Planning Assessment Report

Application to Modify the Minister's Approval for the Erection of Replacement Hill Seating and Grandstand at the Sydney Cricket Ground, Moore Park.

Major Project 06_0136 MOD 1

EXISTING

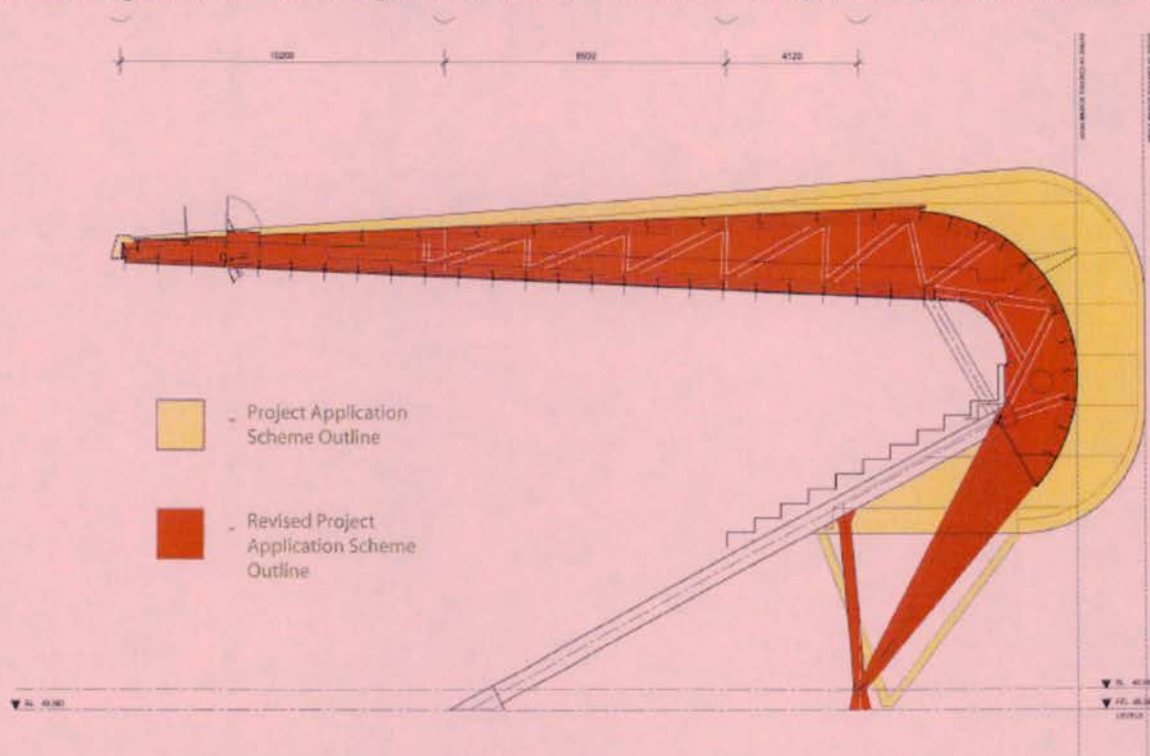
The main noticeable external difference in the proposed modification is the grandstand roofing structure, shown on the following page. The revised shape of the grandstand has resulted in a more streamlined architectural roof shape which has less bulk and scale than the approved structure. The architectural merit of the amended profile is not considered acceptable and needs to be redesigned to improve the architectural articulation and quality of finishes. **Condition B3 has been amended requiring appropriate design changes.**

The overall height of the grandstand has been reduced from RL 64.915 to RL 64.357. The revised design generally reduces the height of the proposed facility, and the overall scale of the roofing structure. The diagram on the below shows the height change of the grandstand.
